Evaluation Kit for RA4M3 Microcontroller Group
EK-RA4M3 v1
Errata

Renesas RA Family
RA4 Series

EK-RA4M3 v1

Figure 1. USB FS Series Resistors R21, R22

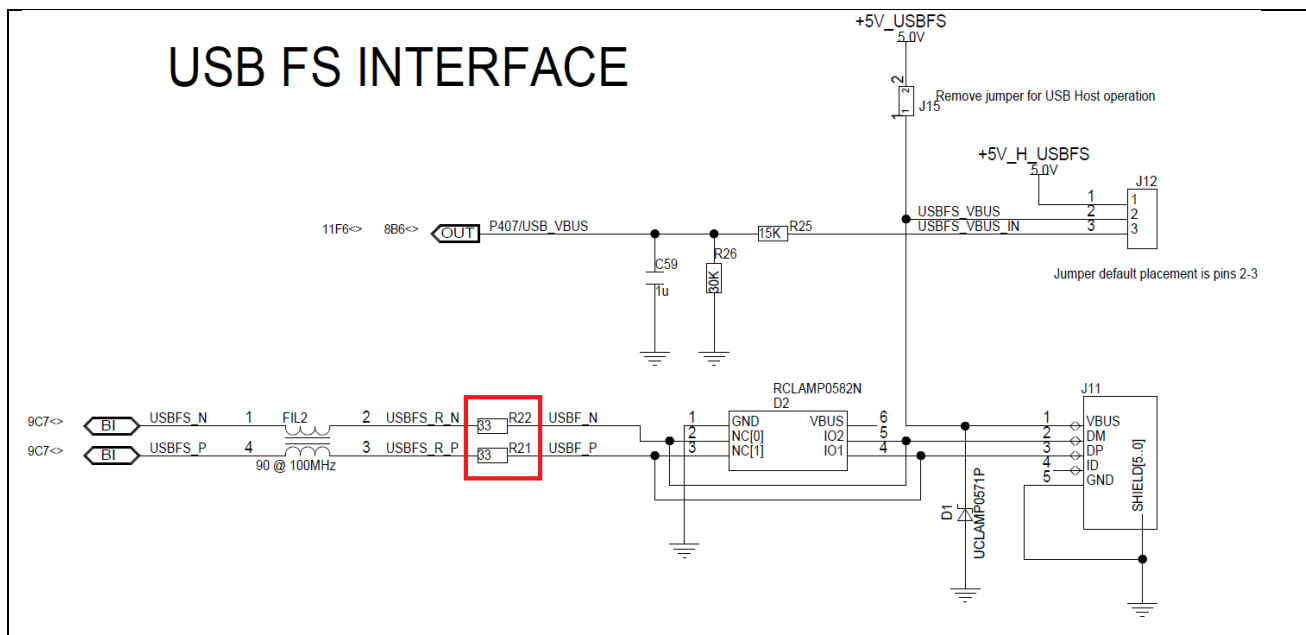
According to the following section in the *RA4M3 Hardware User's Manual*, r01uh0893ej0120-ra4m3.pdf; **26.3.1.4 USB 2.0 Full-Speed Module (USBFS): Example external connection circuits**, the series resistors R21 and R22 in the USB FS interface should have a value of 27 Ω. On affected boards, R21 and R22 are fitted with 33 Ω resistors. The EK-RA4M3 v1 schematic reflects these incorrect values as can be seen in Figure 1.

This kit has been confirmed to work with 33 Ω resistors so there is no need to replace them with 27 Ω resistors.

However, in your circuit design, be sure to insert a 27 Ω resistor into the USB differential line to satisfy the characteristics of the USB module.

None. The resistors R21 and R22 have the correct value of 27 Ω on later builds of the board. The schematic has been updated to show the corrected values.

Figure 2. MCU Pin Header J4 Pin17 Label Error

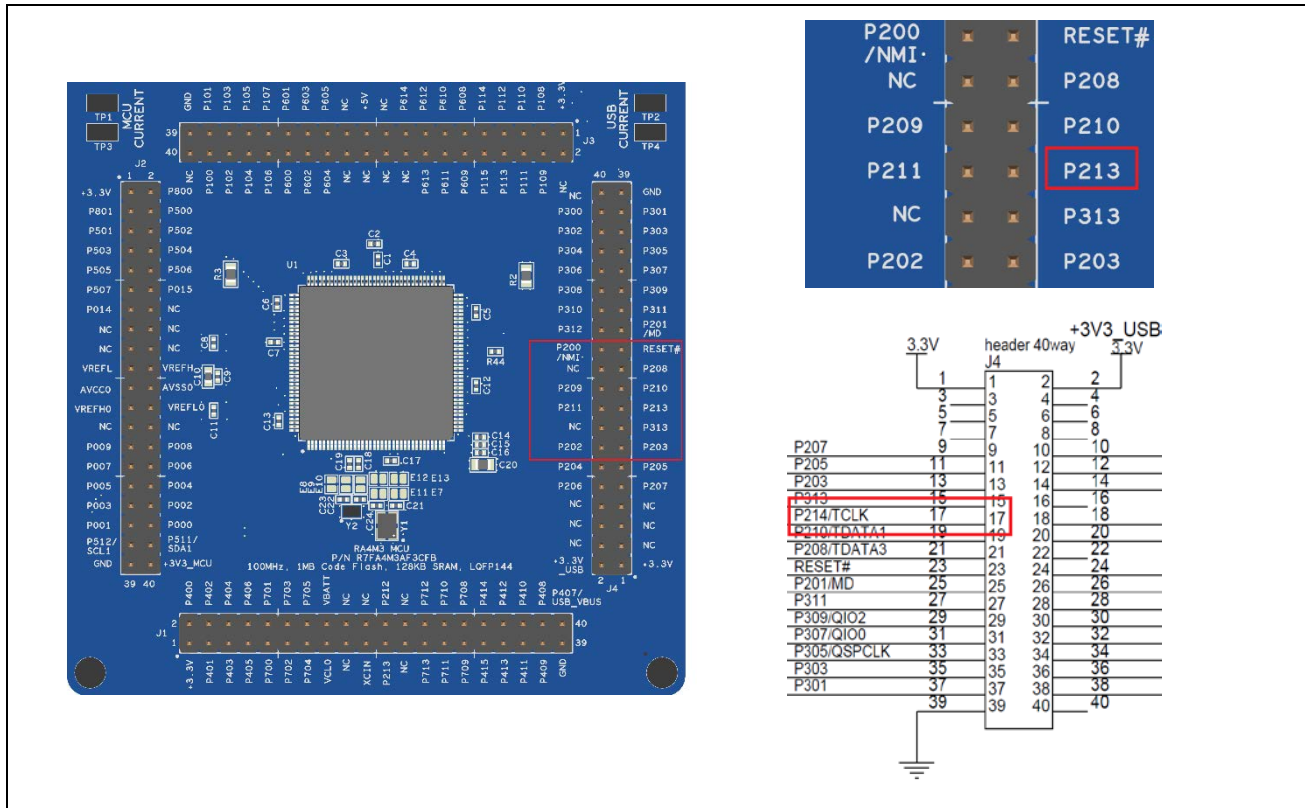
The MCU Pin Header J4 has an incorrect label for pin 17. This is identified as P213 when it should be P214. The schematic is correct.

None. The silkscreen has been corrected to show the correct pin identification on later builds of the board.

Figure 3. MCU UID Leading Zero Not Displayed

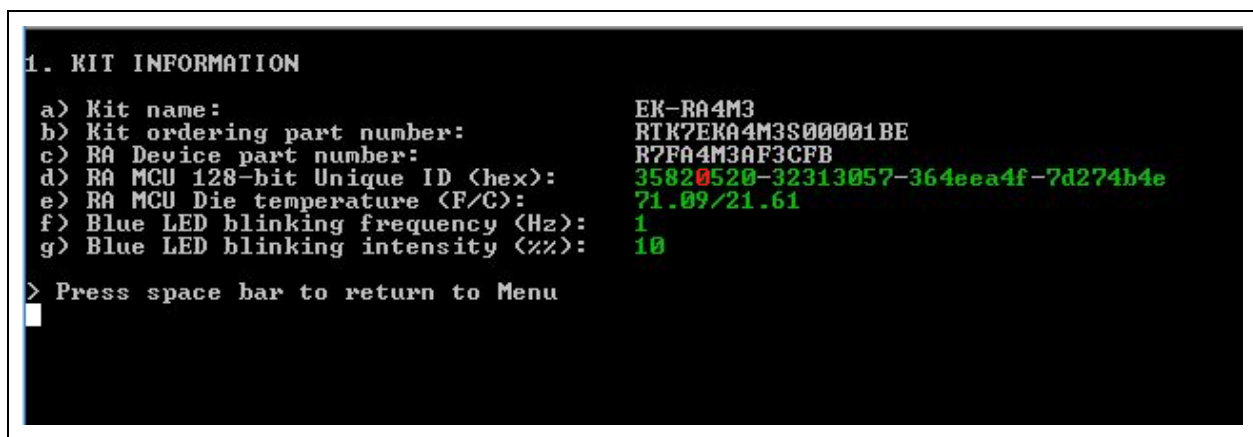
In certain cases, the Quick Start Software programmed into the board may incorrectly display the device UID.

The UID is displayed in 'Kit Information' as a series of 4-byte values *bbbb-bbbb-bbbb-bbbb* as can be seen in the following example. If any single byte is of the form '0000nnnn', that is, has a leading zero, it will not be displayed.

The Quick Start Software programmed into later boards has been updated to show the correct device UID. The latest sample software can be downloaded from;
